VIRGINIA ELECTRIC AND POWER COMPANY
RICHMOND, VIRGINIA 23261

November 28, 1979

Subject: North Anna Power Station Units 1 and 2
GDC-17 Compliance Review Results

NORTH ANNA SWITCHYARD

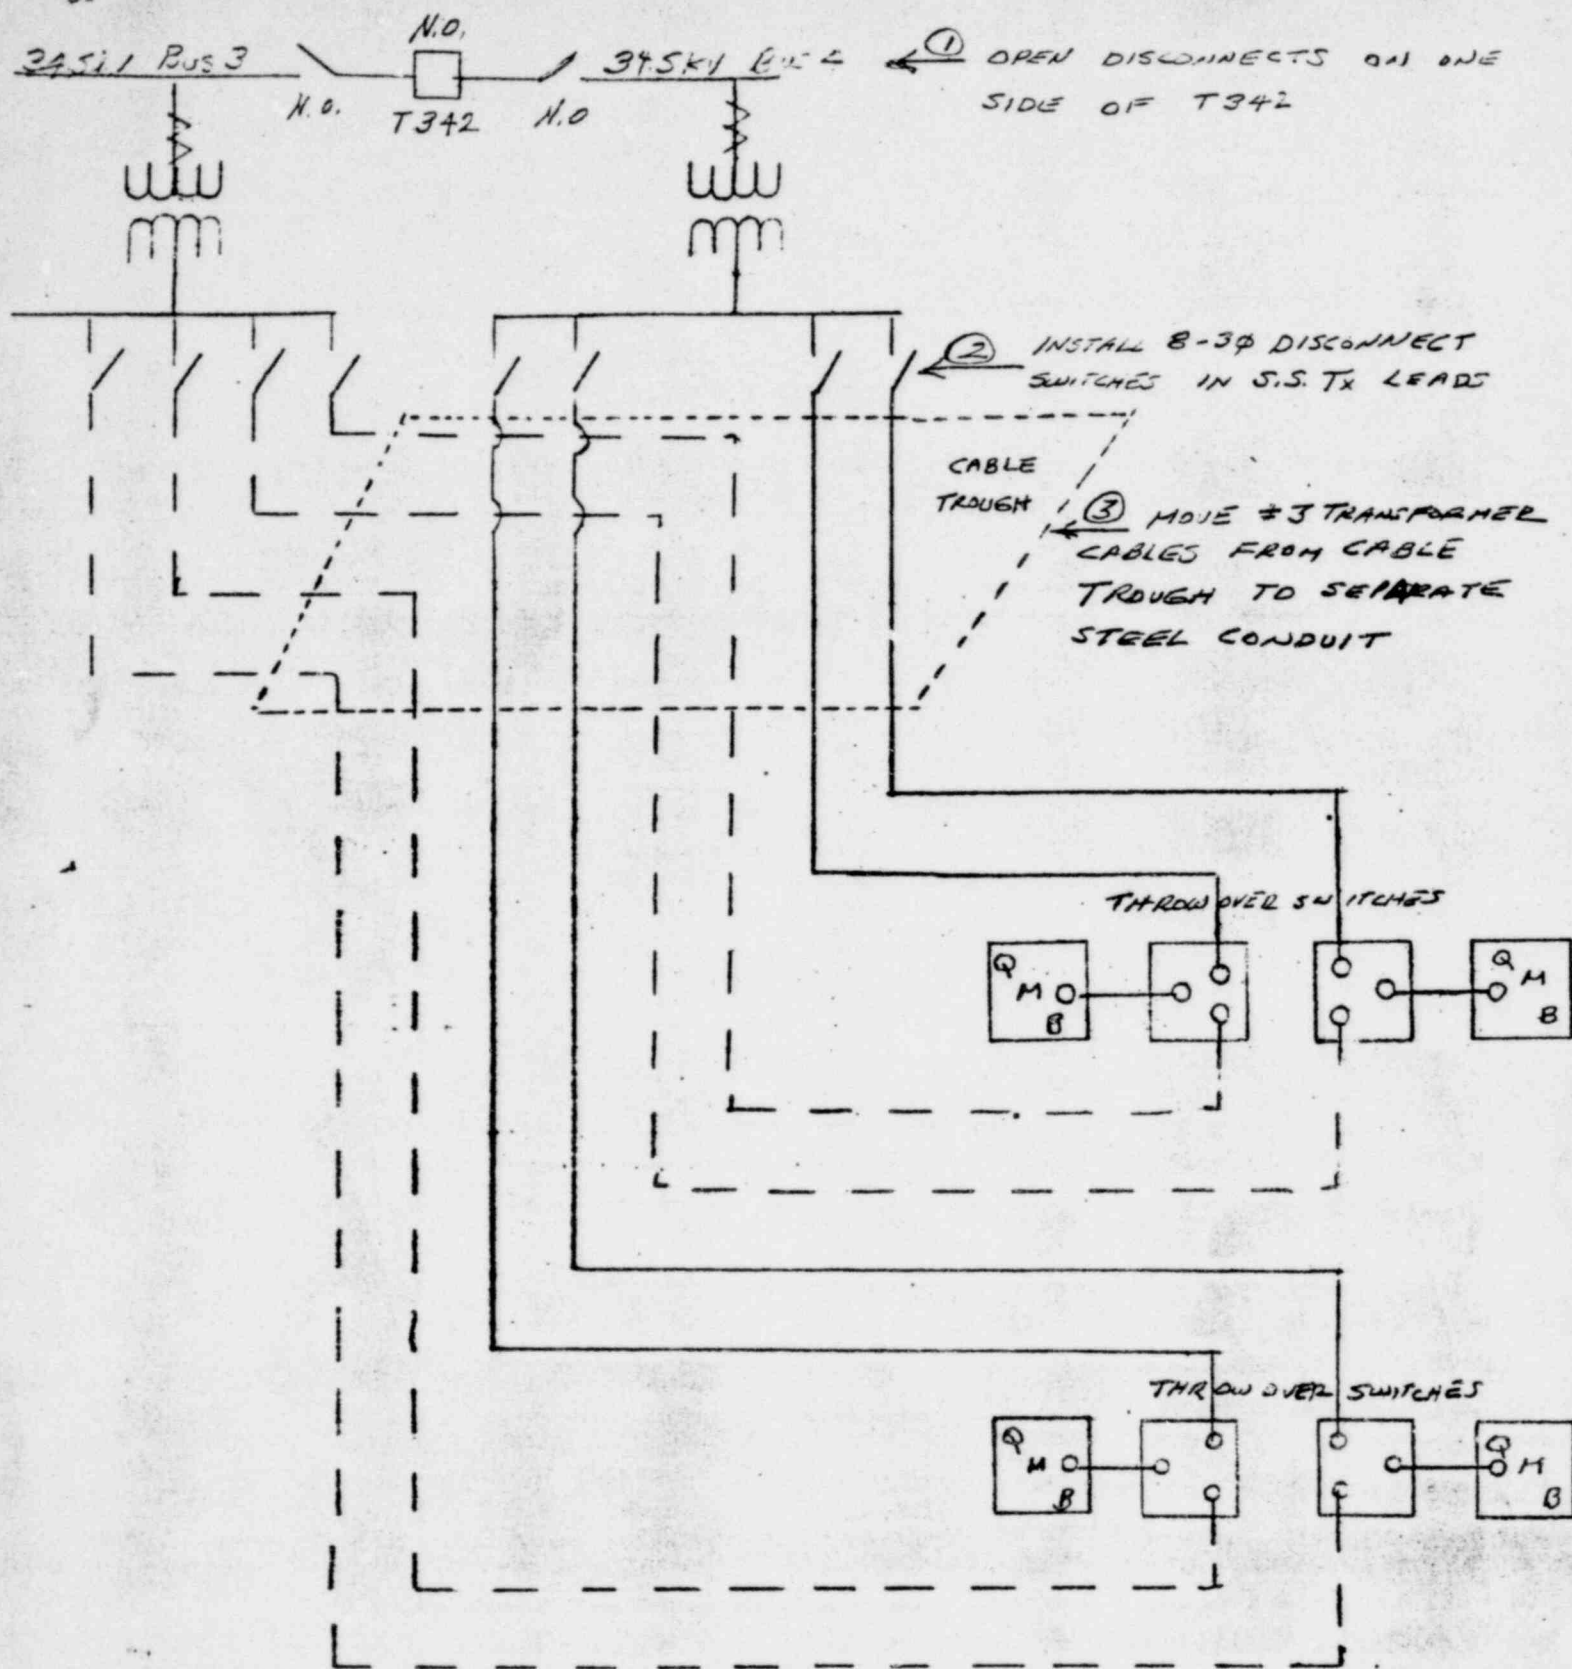
The first area of concern we mentioned in our October 9, 1979, letter involved a 34.5KV tie breaker between the two 34.5KV buses which supply the redundant offsite power supplies. This tie breaker would normally be open and would be automatically closed upon the loss of supply power to either 34.5KV bus. However, to eliminate any possibility of simultaneous loss of both offsite sources due to tie breaker failure, we will incorporate operating procedures to leave one or both 34.5KV disconnects open (one disconnect is installed on each side of the breaker). The automatic close feature will be removed and manual closing will be required.

The second item of concern we expressed in our October 9, 1979, letter involved the switchyard service transformers. Each of these 1500KVA transformers can supply the entire switchyard load. The primaries of these transformers are connected to each 34.5KV bus and the secondaries are routed in a common cable trough to manual throwover switches. The purpose of the throwover switches is to allow the loads to be transferred to either transformer. In

order to eliminate the possibility of simultaneous loss of both offsite sources, switches will be installed in the secondary leads of both transformers and all the secondary leads of one of the transformers will be removed from the common trough and installed in conduit. The new switches will be operated such that only one transformer source will be available at the throwover switch at any time.

Enclosed is a sketch which shows the changes described above. The remainder of the offsite power source is in full compliance with GDC-17 and these changes eliminate the concern of a single event causing simultaneous loss of both required circuits to the offsite source.

NEW DISCONNECT SWITCHES & ASSOCIATED THROW OVER CONTACTS TO BE OPERATED ALL OPEN OR ALL CLOSED AS REQUIRED.
